CHANGE ORDER NO. 3
MAY 22, 1998 - OMIT LEFT TURN LANE

STORM SEWER PLAN / PROFILE										
KELLER SPRINGS ROAD										
DALLAS COUNTY, TEXAS										
TEXAS DEPARTMENT OF TRANSPORTATION										
Half Associates ENGINEERS - ARCHITECTS - SCIENTISTS - PLANNERS - SURVEYORS										
DESIGN	DRAWN	NOTES	FED. NO.	STATE	FEDERAL AID PROJECT NO.	SHEET				
CADD			DIV. NO.	TEXAS	STIP 96 (1993) 488	NO.				
DATE	FILE	SCALE	DIST. NO.	COUNTY	SECTION NO.	JOB NO.	IRRAWAY NO.			
JULY 1998	706STF4	1:500 (PLAN) 1:50 (VERT)	18	DALLAS	089	48	222			CS

CONCRETE SLAB RIPRAP DETAIL
SECTION A-A
N.T.S.

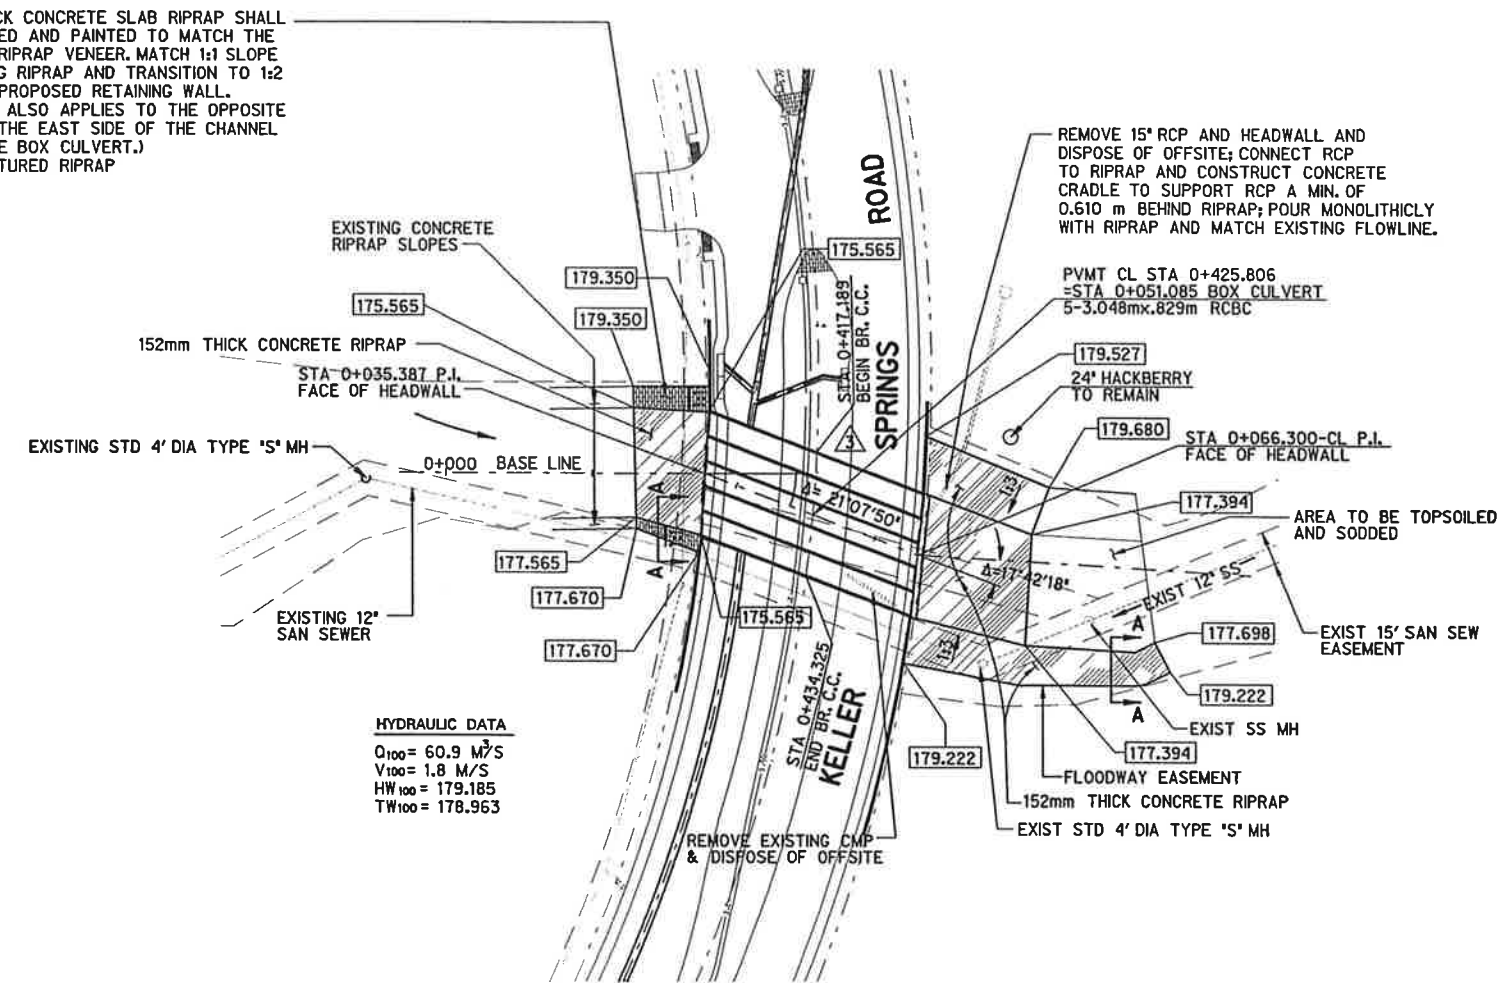
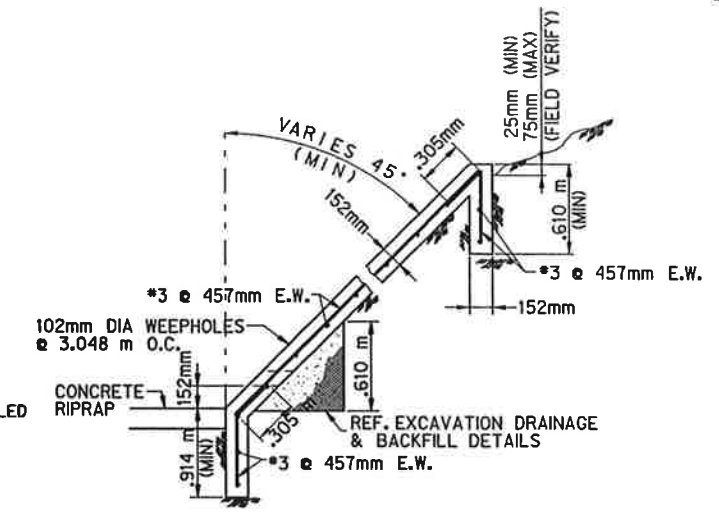
152mm THICK CONCRETE SLAB RIPRAP SHALL BE TEXTURED AND PAINTED TO MATCH THE ADJACENT RIPRAP VENEER. MATCH 1:1 SLOPE AT EXISTING RIPRAP AND TRANSITION TO 1:2 SLOPE AT PROPOSED RETAINING WALL. (THIS NOTE ALSO APPLIES TO THE OPPOSITE SLOPE ON THE EAST SIDE OF THE CHANNEL D/S OF THE BOX CULVERT.)
100m² TEXTURED RIPRAP
